***Response to An Bord Pleanála and
Dun Laoghaire-Rathdown County Council Opinion***

Kilternan Village SHD

Ref: Case Reference: ABP-312007-21

Proposed Development: Demolition of existing structures, construction of 383 no. residential units (165 no. houses, 118 Duplexes, 100 no. apartments), creche and associated site works. Lands at Wayside, Enniskerry Road, Kiltarnan, Dublin 18.

Figure extracted from the Kiltiernan LAP Main Map.

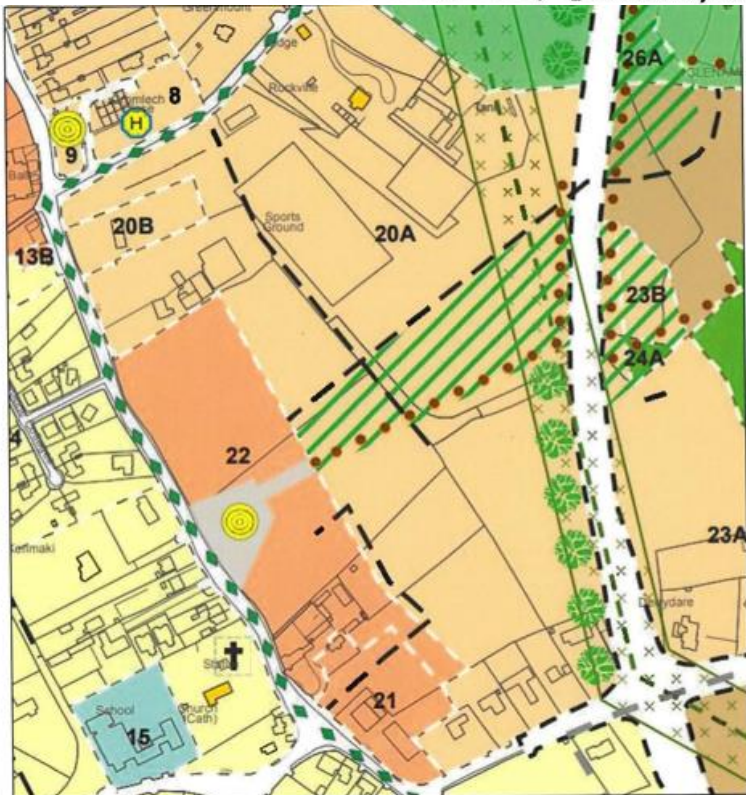
- Passive surveillance of 'Dingle Way' greenway should be improved

The passive surveillance/supervision of the Dingle way has greatly improved with the redesign and reordering of the materials at the Village green. It is further noted that the inclusion of a community facility greatly increases the passive supervision along the Dingle Way. The proposed paving, seating, green area and tree planting of columnar trees provide a destination space and civic area which is activated.

The Dingle Way will be accessed and passively supervised in a safe and controlled manner.
